IREDELL COUNTY HEALTH DEPARTMENT

Statesville Office (704) 878-5305 Mooresville Office (704) 660-3625 PERMIT # 234454

SEPTIC IMPROVEMENT PERMIT / AUTHORIZATION TO CONSTRUCT / OPERATION PERMIT / EXISTING SYSTEM

APPLICANT/OWNER: Sherry Johnson APPLICANT ADDRESS: 140 Maxwell Statesville NC 28677

AS BUILT SKETCH

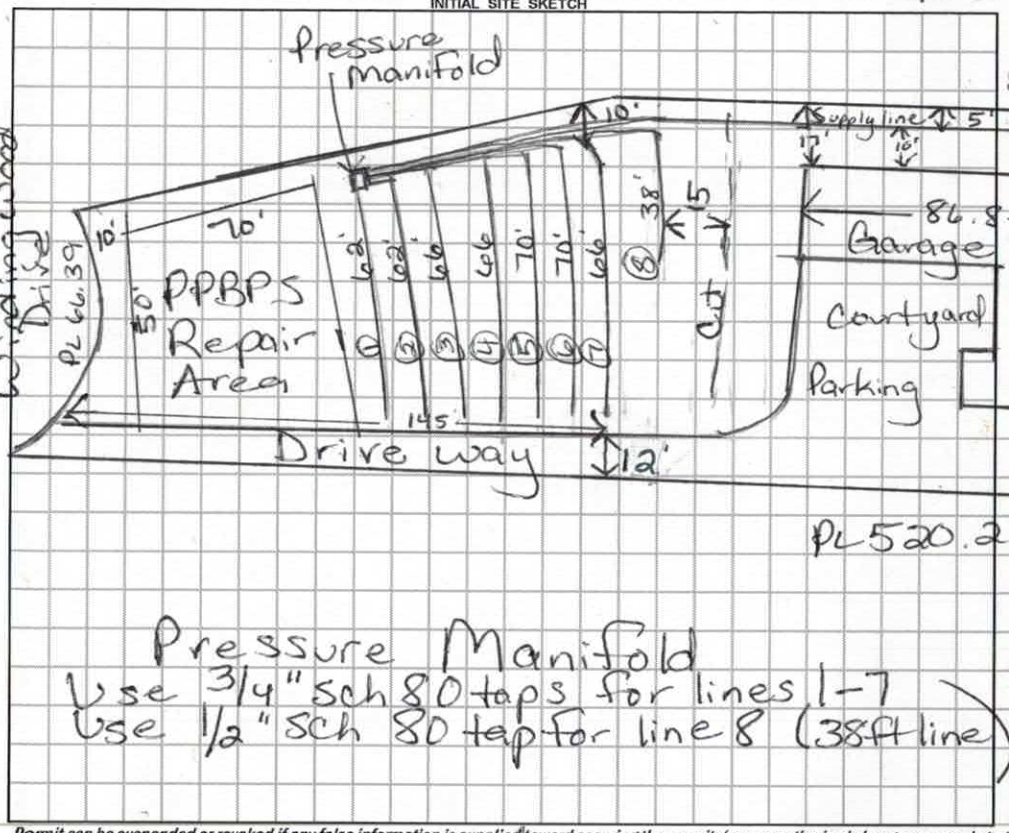
Comments / Conditions: Divert storm/surface water max away from Septic * Neighbor's "Proposed well"

Keep Drain lines a minimum of 15ft from "cut" Keep tanks minimum 50ft from well

Pressure Manifold
Use 3/4" sch 80 taps for lines 1-7
Use 1/2" sch 80 tap for line 8 (38ft line)

* lines: 6 chambers @ 42" > need to remove 6"
line 6: 5 chambers @ 42"

INITIAL SITE SKETCH

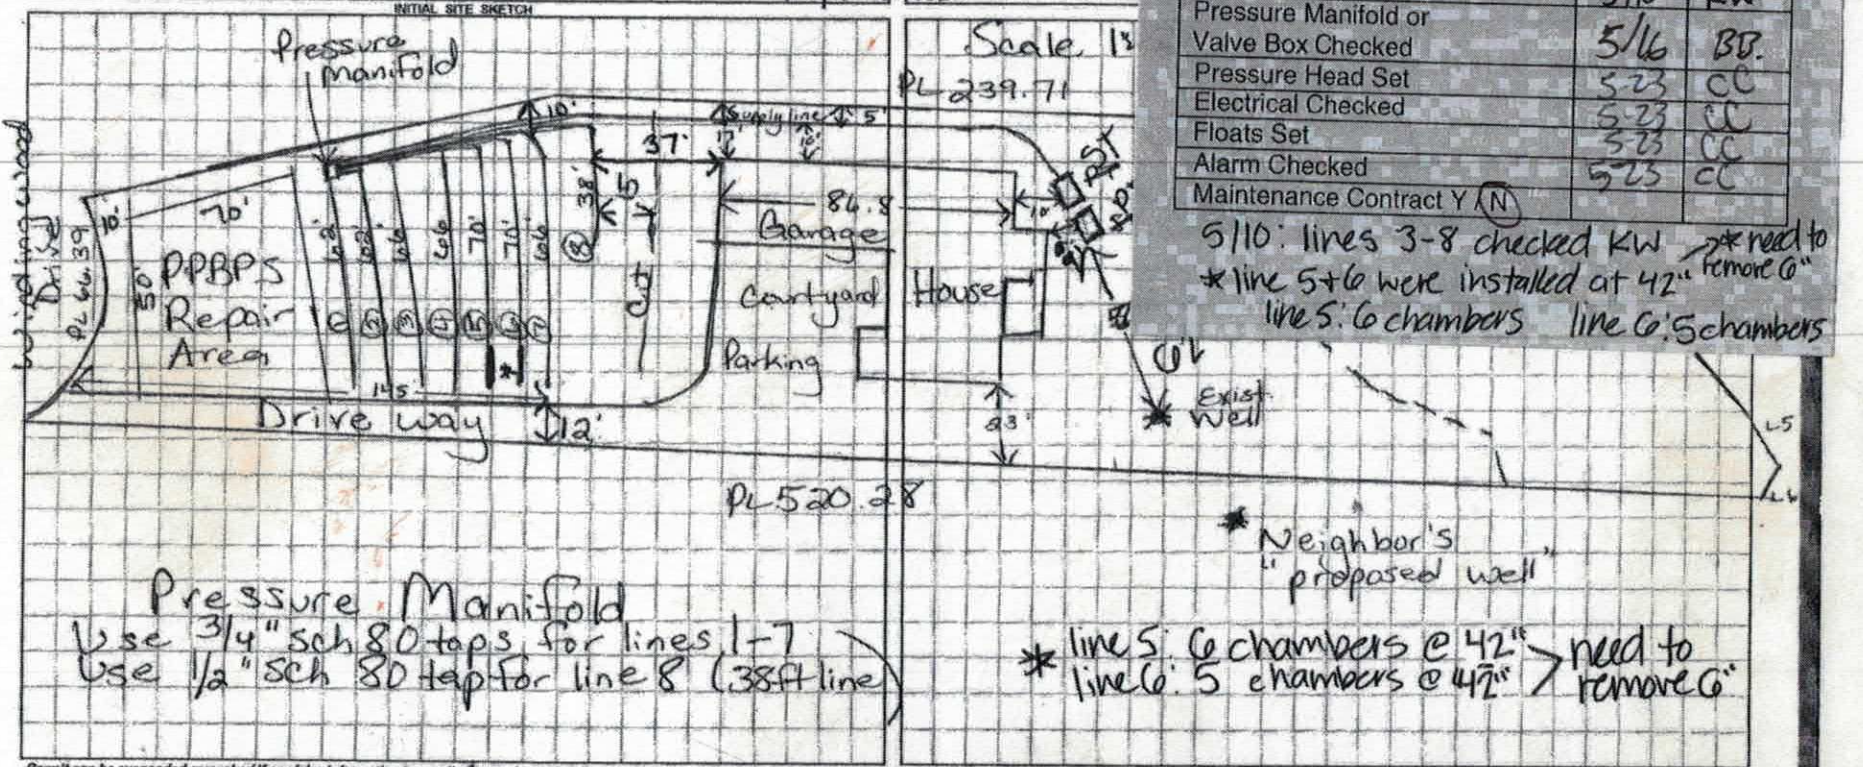
Pressure Manifold
Use 3/4" sch 80 taps for lines 1-7
Use 1/2" sch 80 tap for line 8 (38ft line)

* Needs 8 more Feet 5/16
CHECKED 5/20/19 BCW

5/10: lines 3-8 checked KW
* line 5+6 were installed at 42" > need to remove 6"
line 5: 6 chambers line 6: 5 chambers
